Re: Florida Power & Light Company
Proposed Turkey Point Units 6 and 7
Docket Nos. 52-040 and 52-041
Response to NRC Request for Additional Information Letter No. 037
(eRAI 5896) SRP Section - 02.05.02 Vibratory Ground Motion

FPL Response to NRC RAI No. 02.05.02-2 (eRAI 5896)

NRC RAI Number: 02.05.02-2 (eRAI 5896)

Re: Florida Power & Light Company
Proposed Turkey Point Units 6 and 7
Docket Nos. 52-040 and 52-041
Response and Response Schedule to NRC Request for Additional Information
Letter No. 037 (eRAI 5896) SRP Section - 02.05.02 Vibratory Ground Motion

Figure 9b. Caribbean 25Hz weighted mean attenuation curve for a magnitude 7 earthquake.

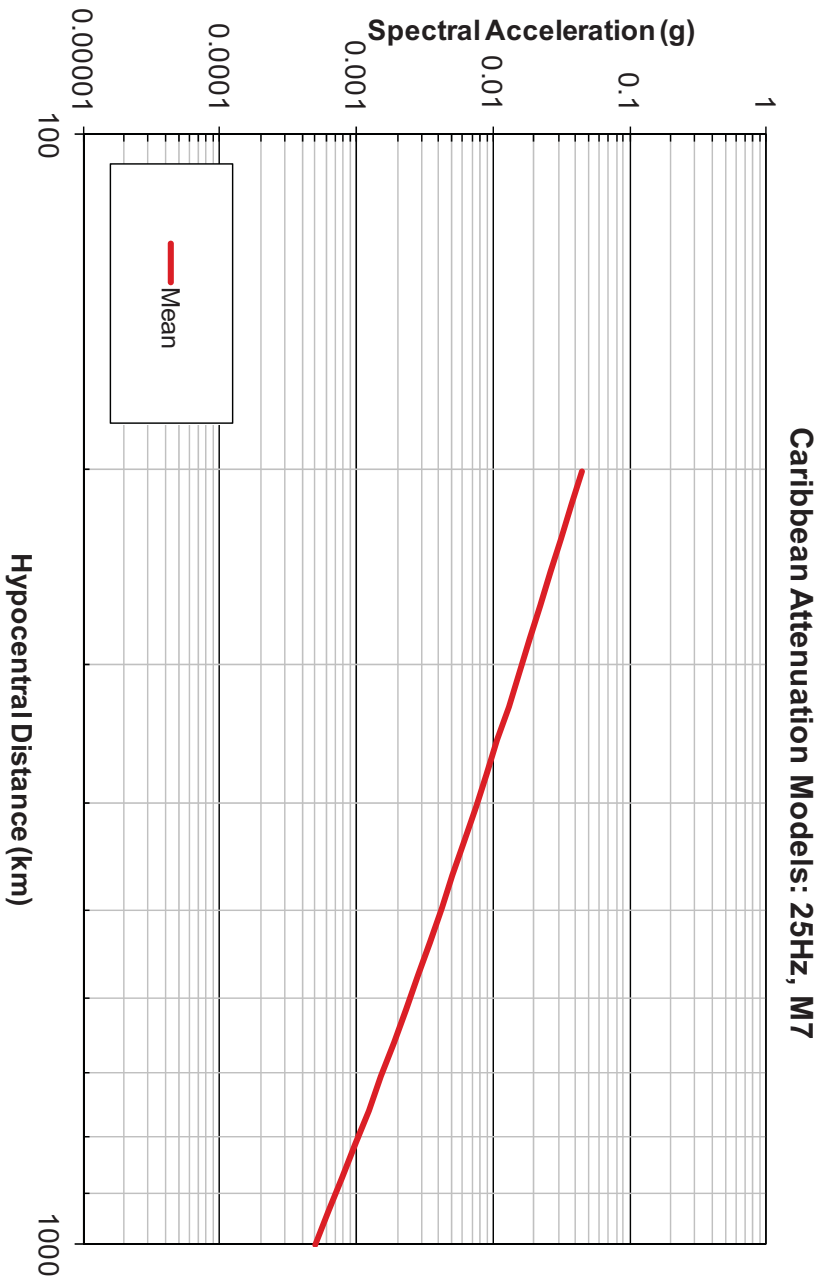
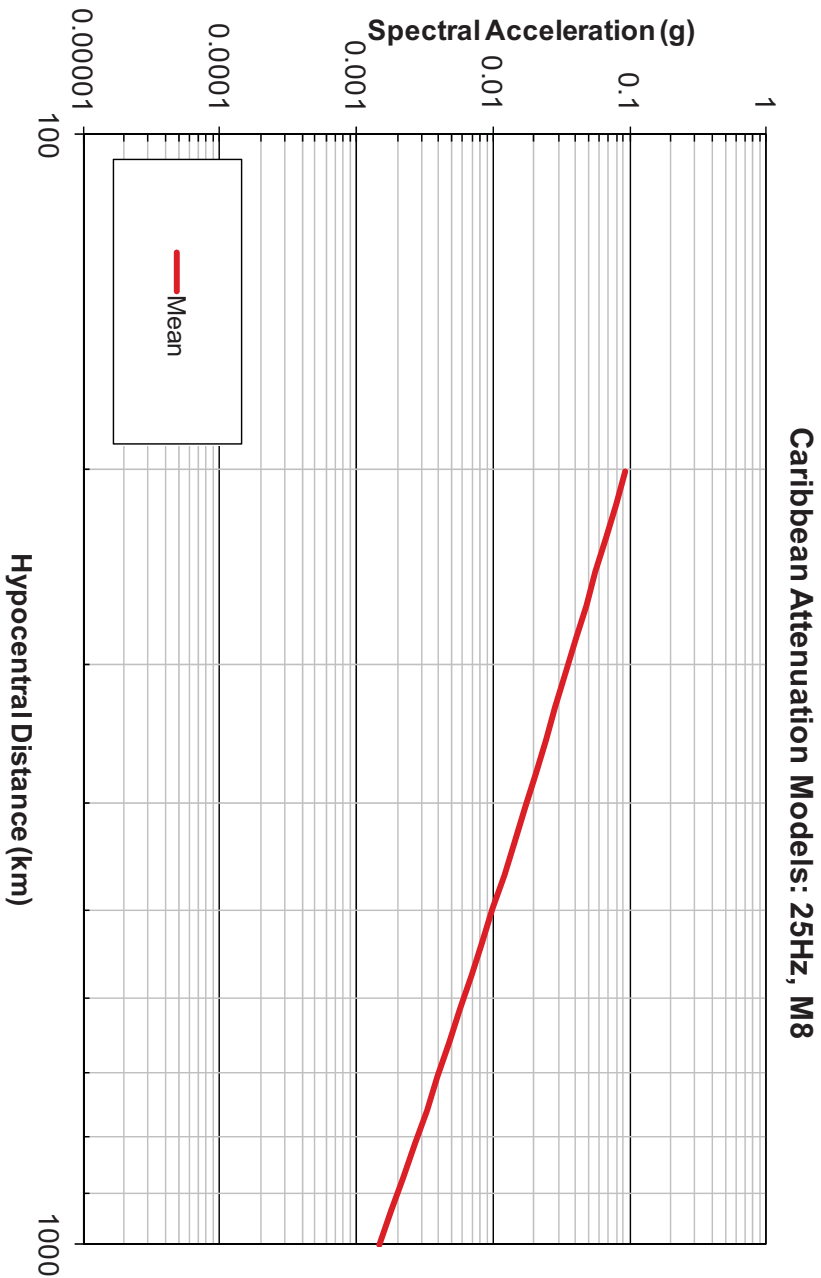
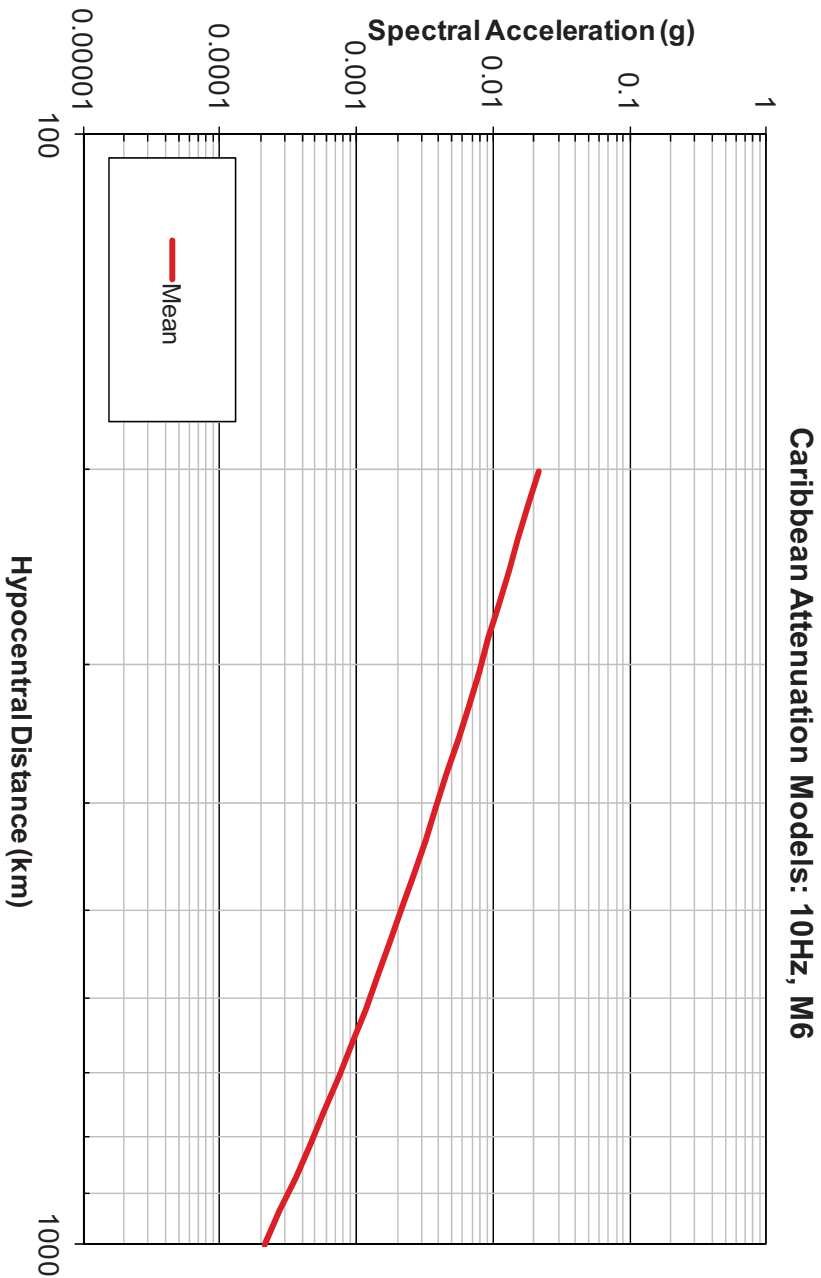
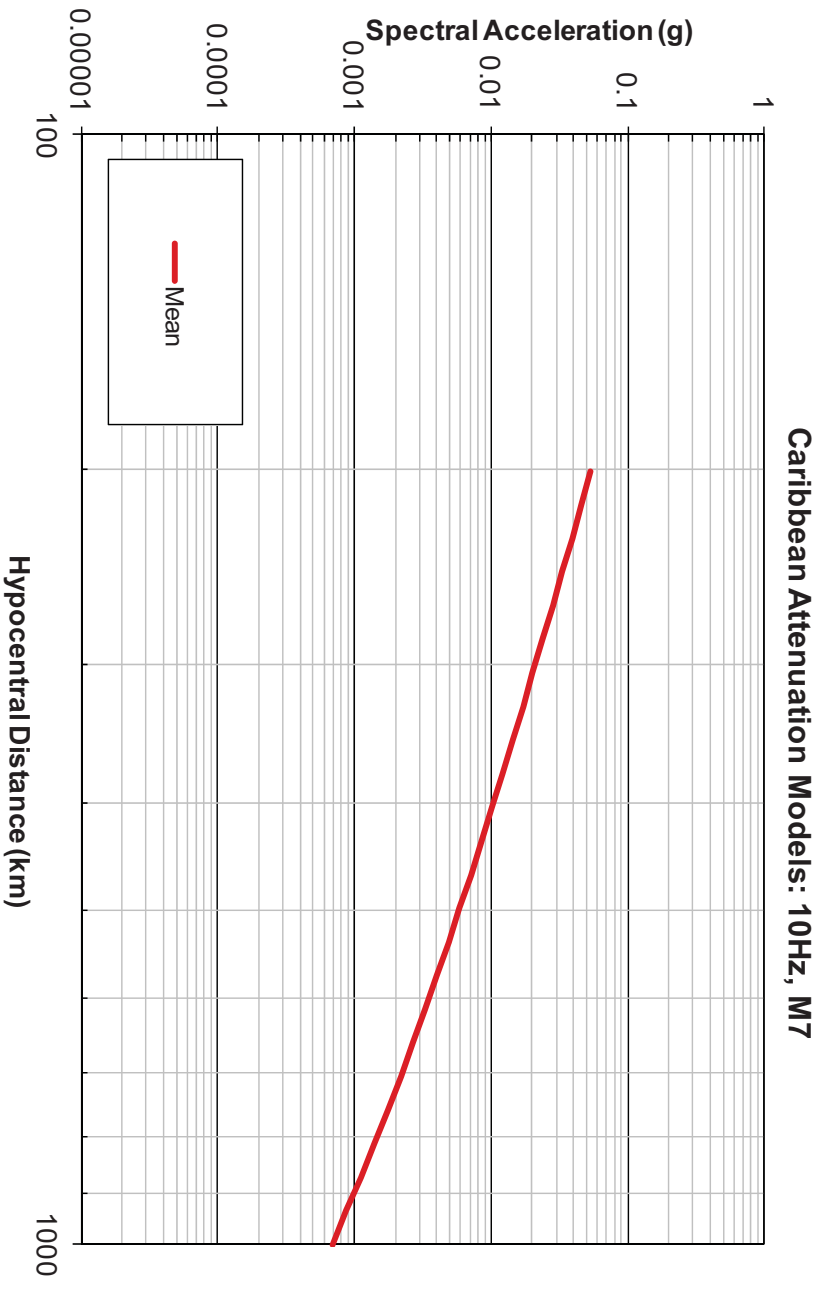
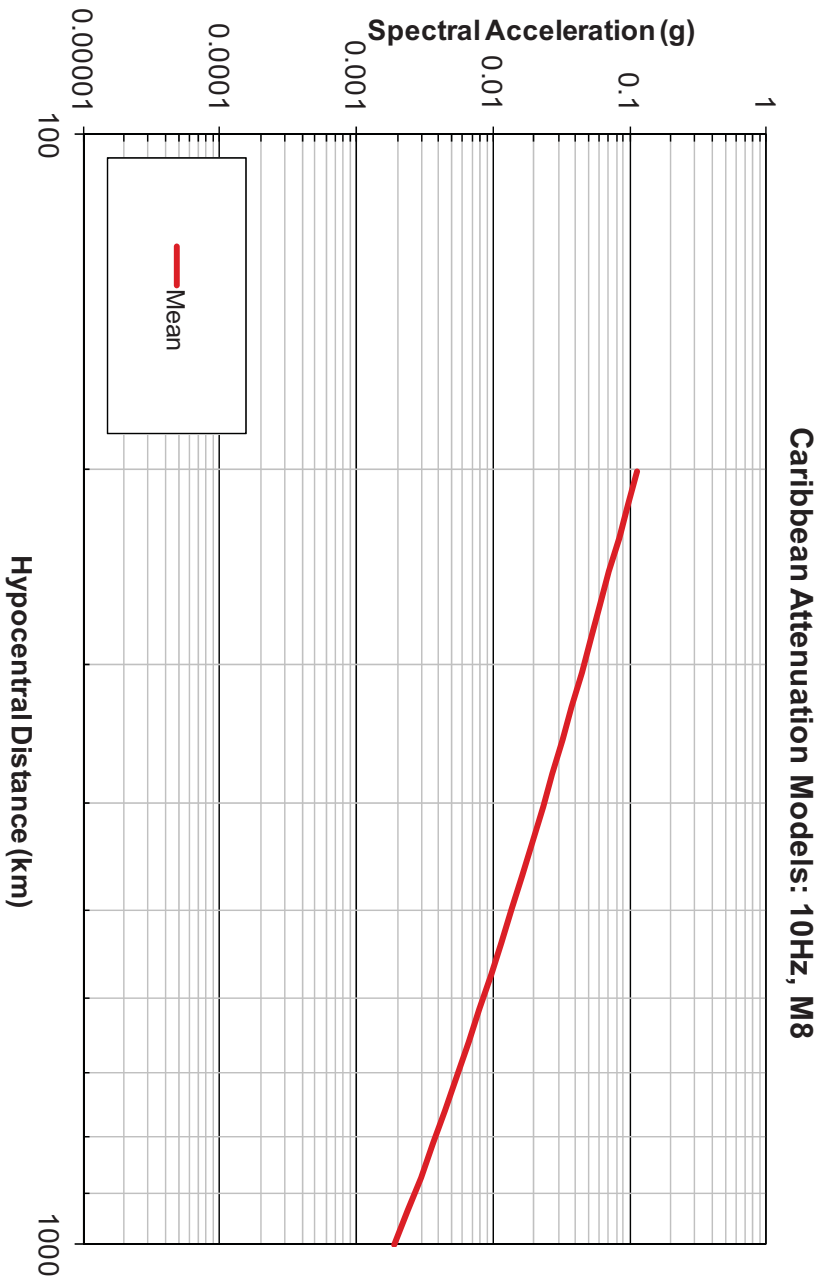
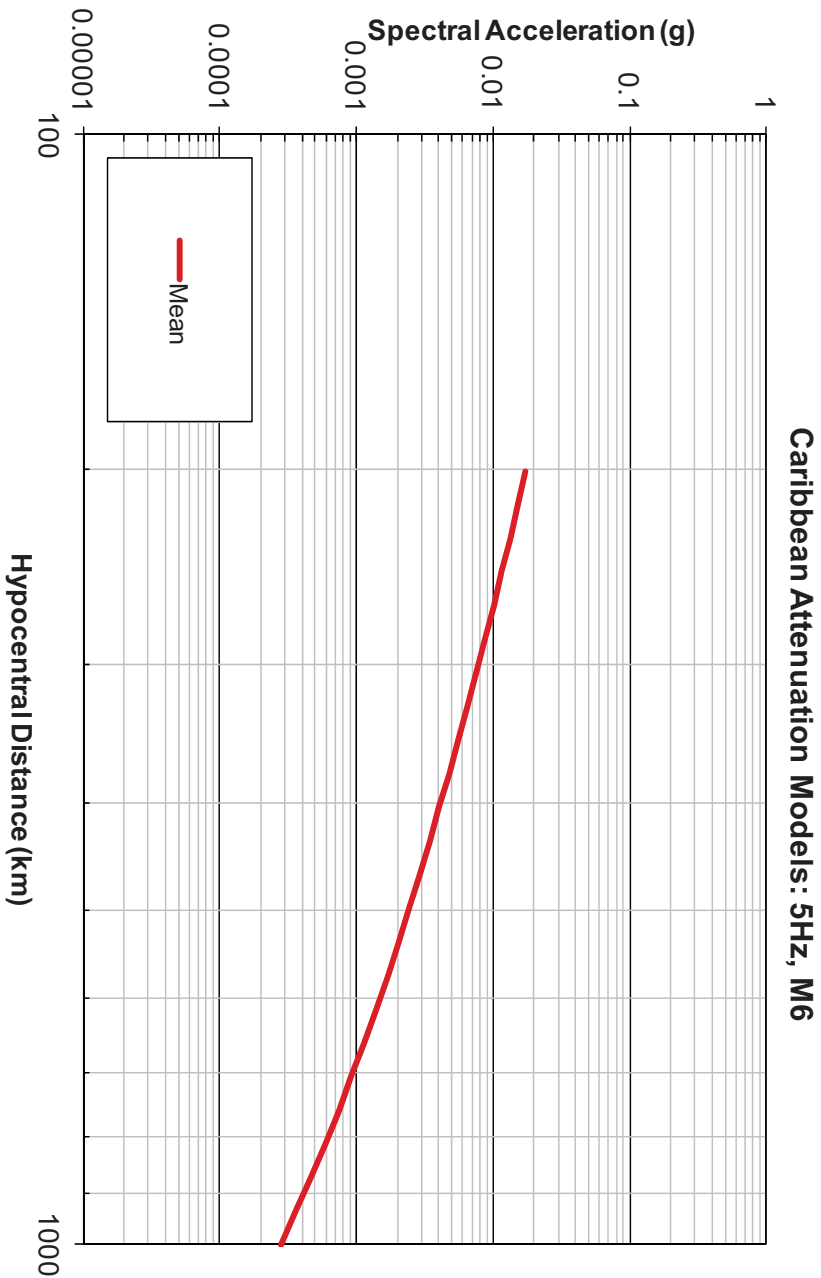
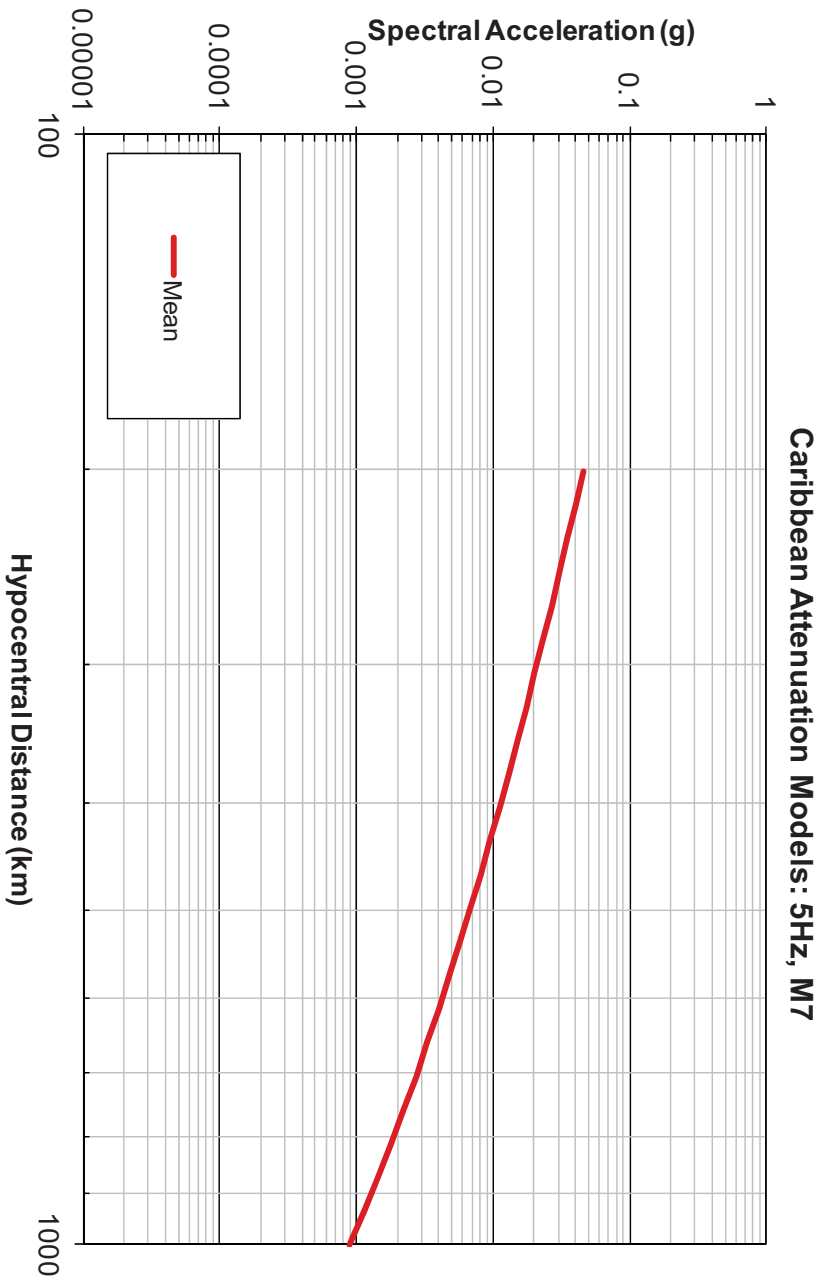
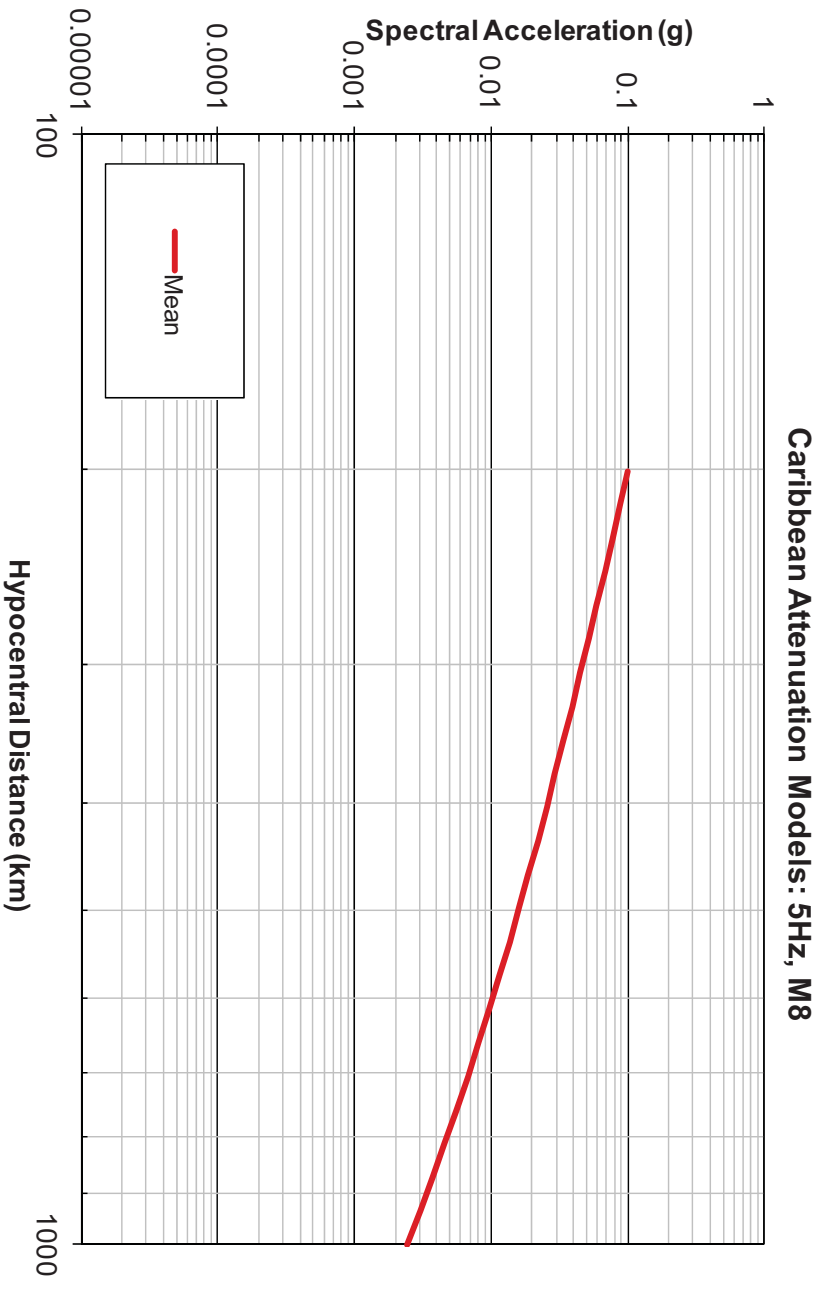
- d. In order for the staff to be able to compare the new Caribbean GMPEs with the 2004/2006 EPRI mid-continent GMPEs, please provide plots showing both ground motion models for earthquake magnitudes of 6.0, 7.0, and 8.0 in the distance range of 200 km to 1000 km at all seven frequencies defined in the EPRI 2004 and 2006 GMPEs.

Ground motion attenuation curve plots are provided for the EPRI (FSAR References 242 and 203) and Caribbean ground motion prediction equations (GMPEs). Note that EPRI (FSAR Reference 203) is only a recommendation for the associated aleatory uncertainty and therefore does not impact the comparison plots of the weighted mean ground motion

attenuation curve. The plotted mean attenuation curve is the weighted mean of the individual median attenuation curves as defined in EPRI (FSAR Reference 242). These attenuation plots are provided for three specific moment magnitude (M_w) values: 6, 7, and 8 for distances between 200 km and 1,000 km. Note that the EPRI (FSAR Reference 242) ground motion attenuation model is defined as a function of epicentral distance, whereas the Caribbean ground motion attenuation model is defined as a function of hypocentral distance. However, because the closest distance is 200 km, the difference between the epicentral and hypocentral distances would be less than 1% for a typical crustal depth of 10 km and even smaller for larger distances out to 1,000 km.

The weighted mean ground motion attenuation curves for the EPRI (FSAR Reference 242) model are given in Figures 1 through 7 for the three magnitudes and seven spectral frequencies requested in the RAI. The weighted mean Caribbean ground motion attenuation curve plots for the same suite of magnitudes, distances, and spectral frequencies are shown in Figures 8 through 14.
